Re: State of Utah Division of Radiation Control ("DRC") Request for Information Letter of January 12, 2011 Regarding Reclamation Plan Revision 3.2A, Utah Radioactive Materials License UT1900479

This letter transmits Denison Mines (USA) Corp's proposed addendum, entitled Revision 3.2 Edition B to the approved Reclamation Plan Revision 3.0 and submittals referred to as Revision 3.1 for White Mesa Mill ("Revision 3.0/3.1"). This letter also responds to DRC's Request for information ("RFI") letter of January 12, 2011 requesting additional changes to previously submitted versions of this document. As requested in the DRC letter, the addendum has been entitled Reclamation Plan Revision 3.2.Edition B ("Revision 3.2.B"). and all changes have been linked to the previously approved version, Revision 3.0/3.1.

**White Mesa Mill Reclamation Plan**  
**Revision 3.2 Edition B (“Revision 3.2.B”)**  
**Addendum/Changed Pages**

**FIGURE A-5.1-3**  
**RECLAMATION COVER AND CROSS SECTIONS**  
**RECLAMATION PLAN REVISION 3.2.B**

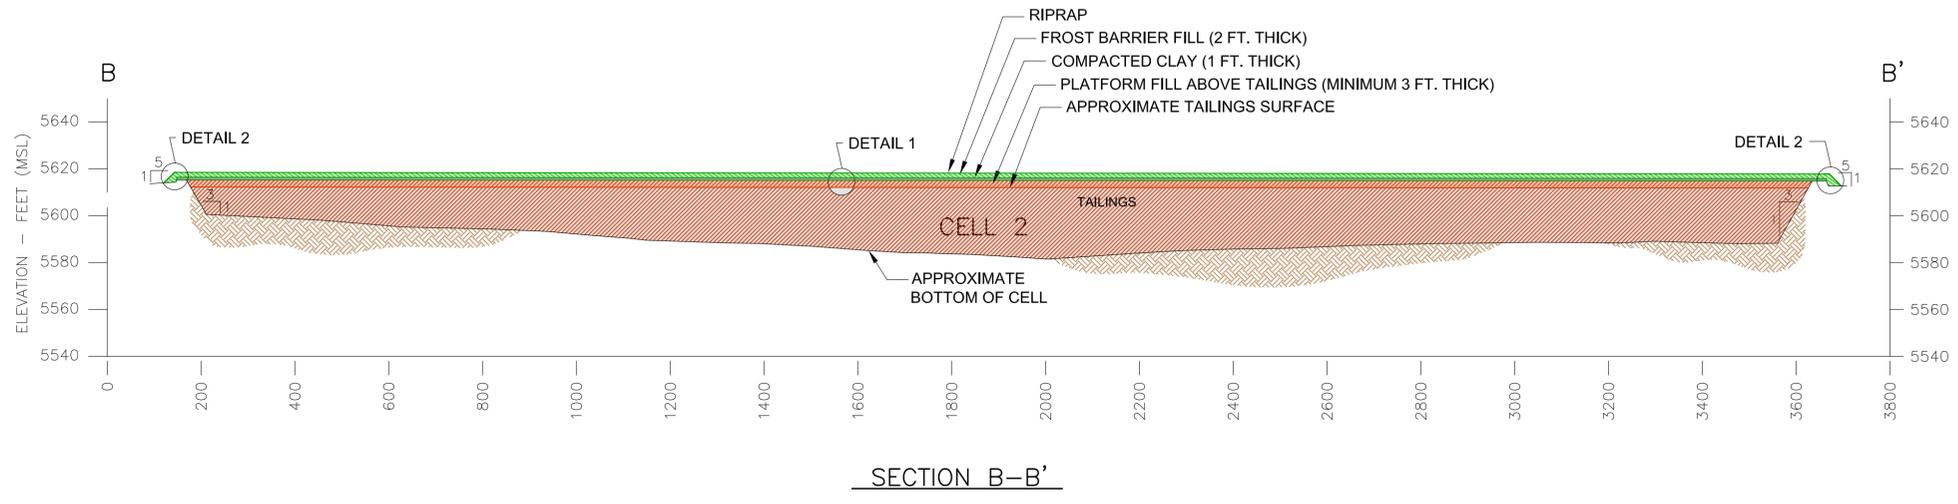
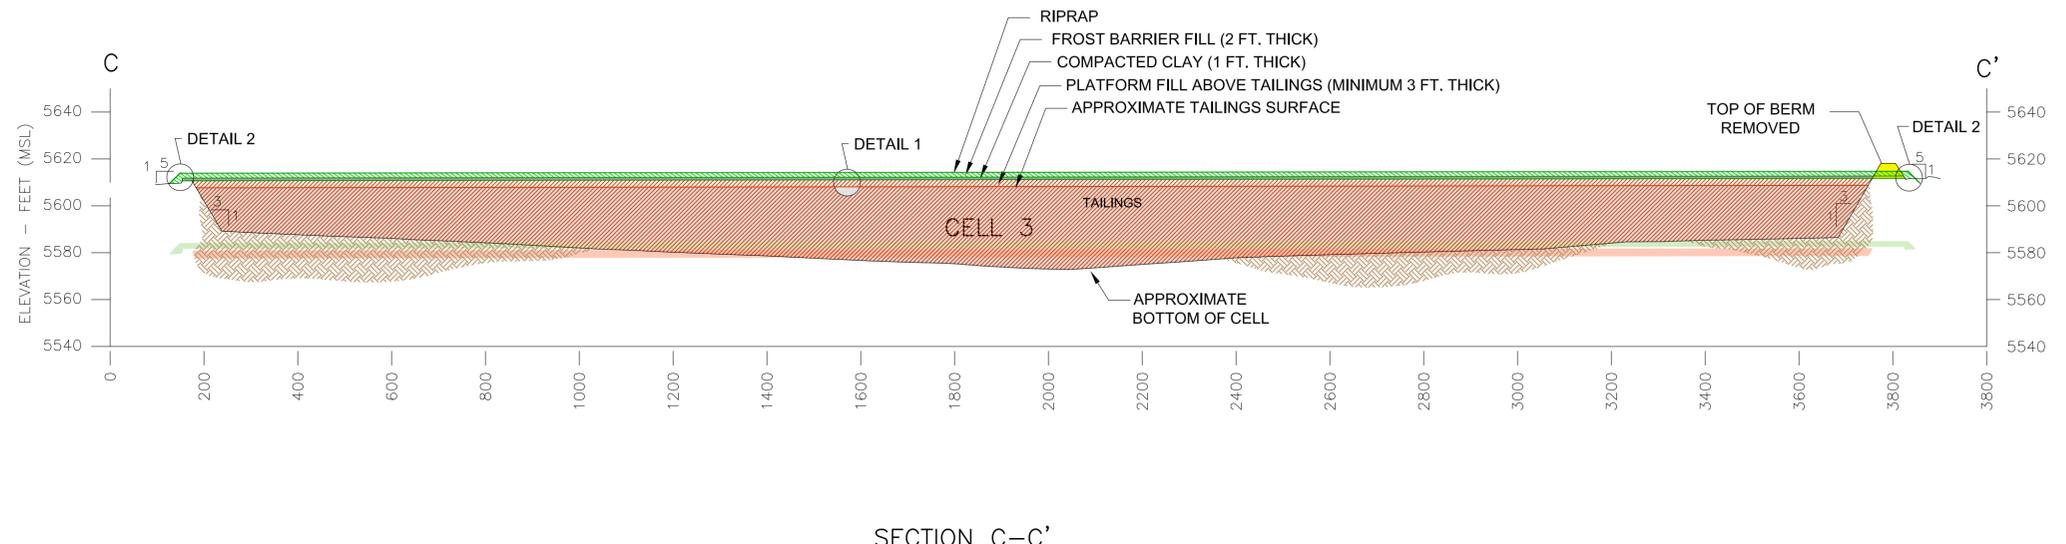
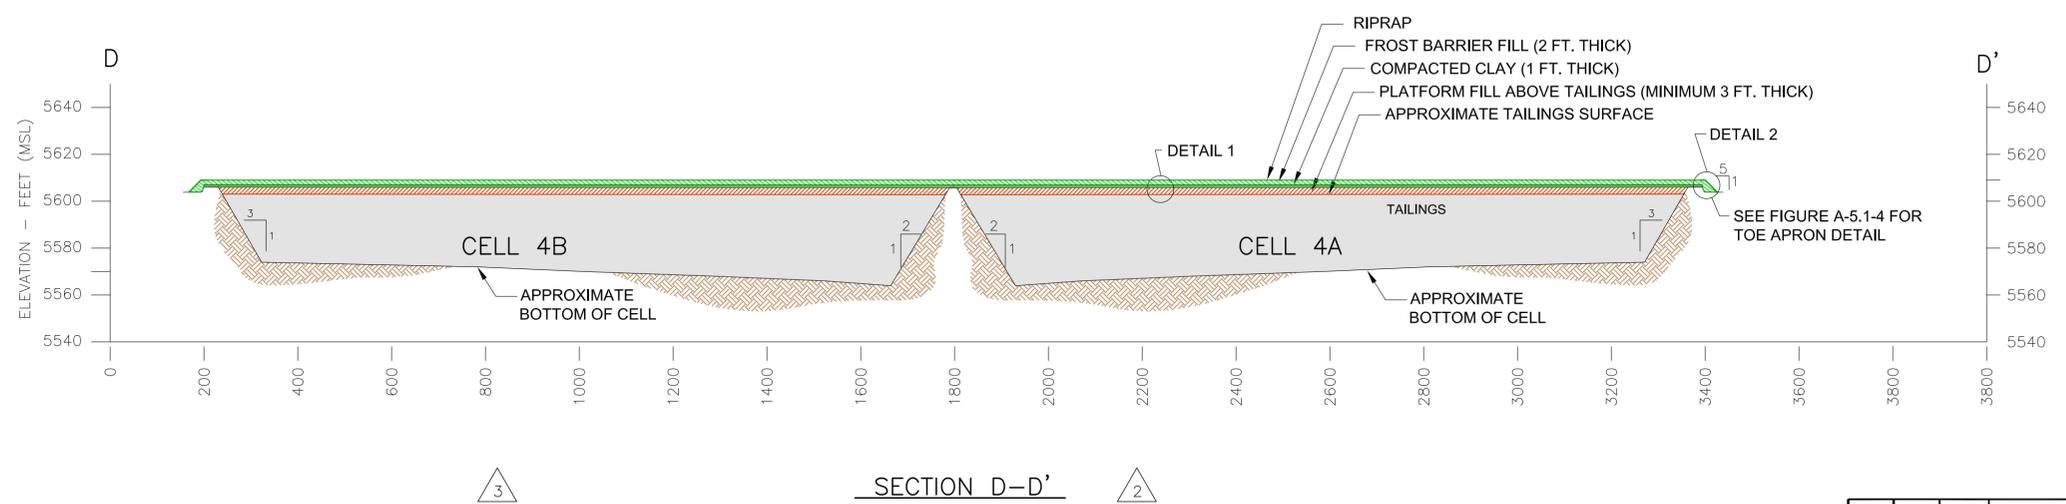
a. Correct a transposition of figure numbers by changing the figure numbers proposed as Figures A-5.1-2 and A-5.1-3 in Rev. 3.2A to correspond to the figures of the same number from Rev. 3.1.

b. Section D-D' needs to be revised to include the addition of Cell 4B.

Denison Response: The transposition of figure numbers has been corrected.

Denison Response: Section D-D' has been revised to include Cell 4B.

FIGURE A-5.1-2  
 RECLAMATION COVER DETAILS & CROSS SECTION  
 RECLAMATION PLAN REVISION 3.2.B

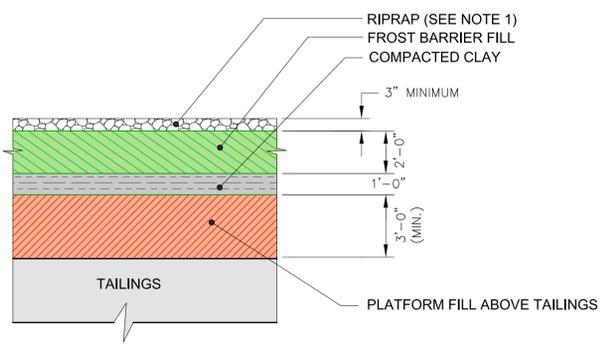
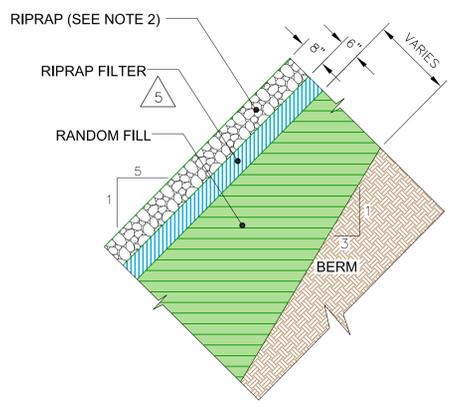
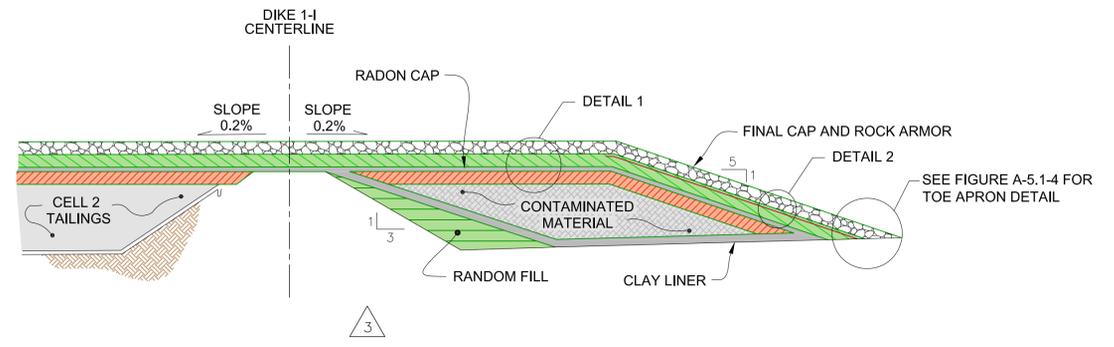
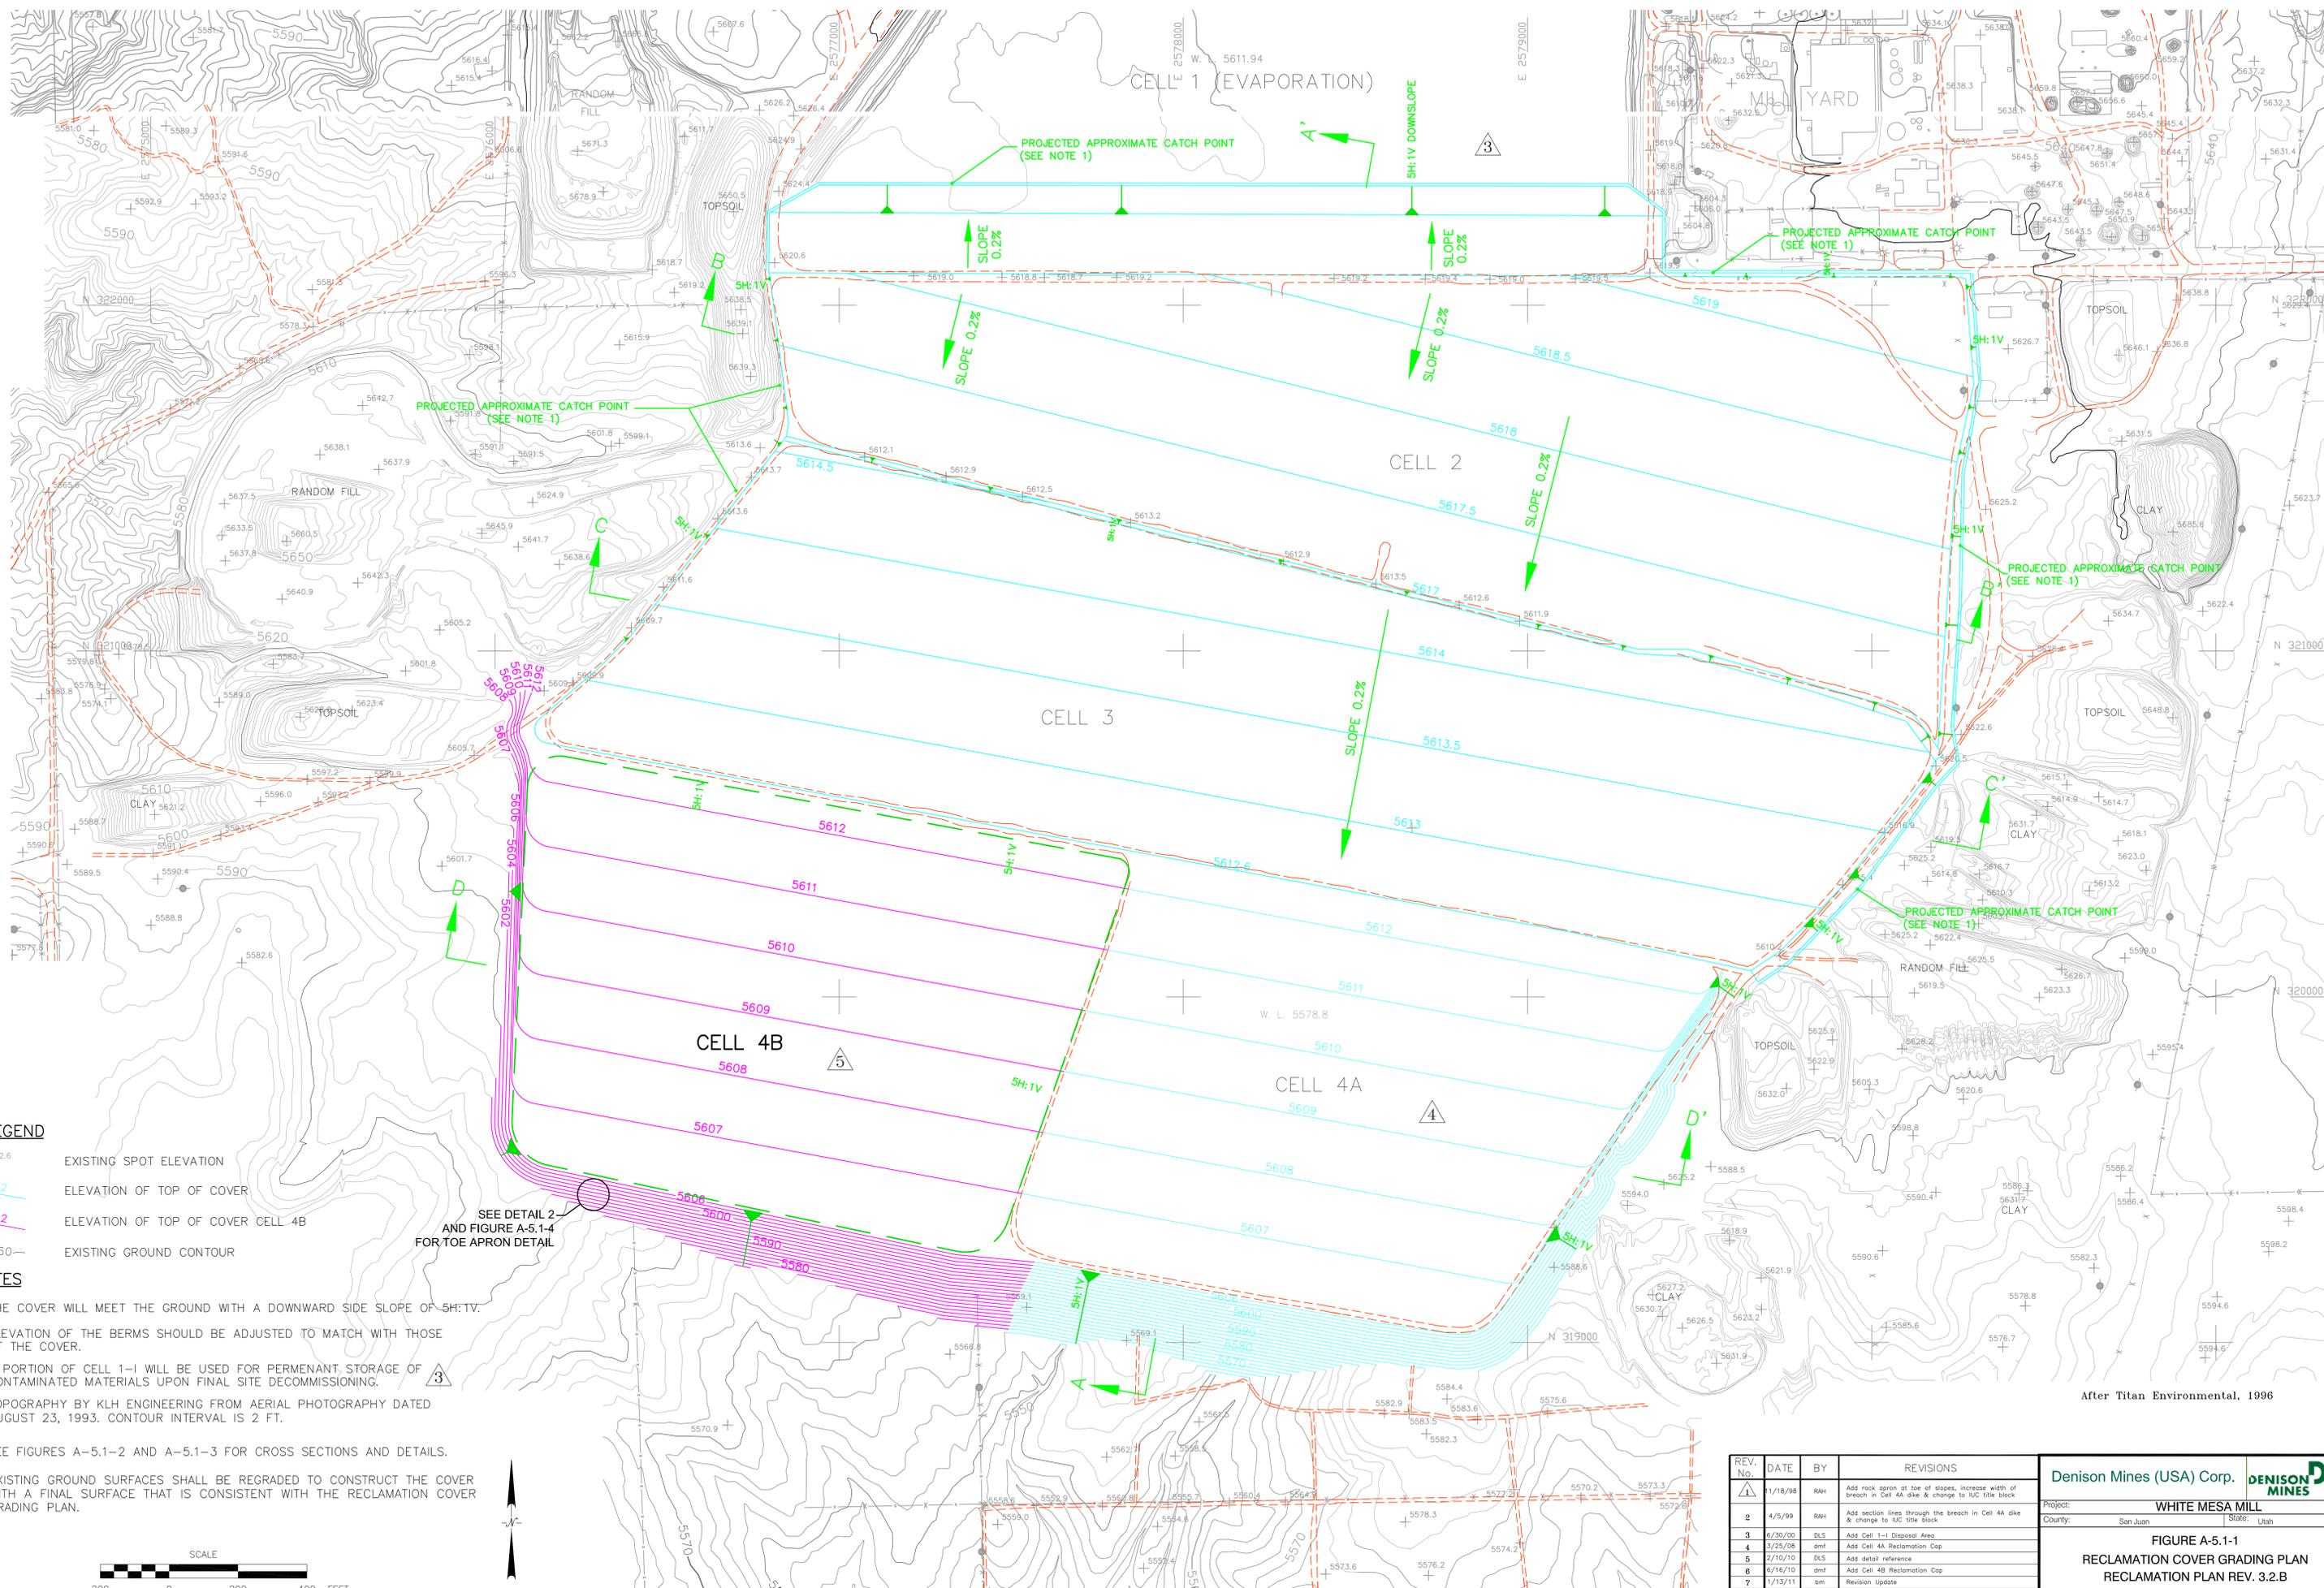
1. Our letter of November 30, 2010, paragraph 3, stated that, "Existing Figure A-S.1-2 in approved Revision 3.1 appears to contain cross Sections and details which are essential to be retained in the Reclamation Plan."

a. Therefore, existing Figure A-5.1-2 must somehow be retained 'and not replaced by the Addendum..."

The referenced Figure A-5.1-2 in Reclamation Plan Rev. 3.1 (labeled on the figure to include drawings through Rev. No.4 dated July 9, 2008), provides Section A-A' and Details 1 through 3. The figure is titled, "... Reclamation Cover Details. and Cross Section."

In contrast, Reclamation Plan Rev. 3.2 provided a Figure A-51-2 titled, "Reclamation Cover and Cross Sections ... " This figure provided Sections B-B', C-C', and D-D'. Not the same sections or details as Rev. 3.1. As stated in DUSA's letter of June 29, 2010, it appeared that this figure was provided as a "replacements for" the figure of the. same figure number. However, the latter Figure A-5.1-2 (Rev. 3.2) does not contain any of the drawings provided in the earlier Rev. 3.1 figure of the same name. Therefore, to keep the original drawing concepts provided on Figure A-5.1-2 (Rev. 3.1), DRC requested that the, "existing Figure A-5.1-2 must somehow be retained and not replaced by the Addendum ... "
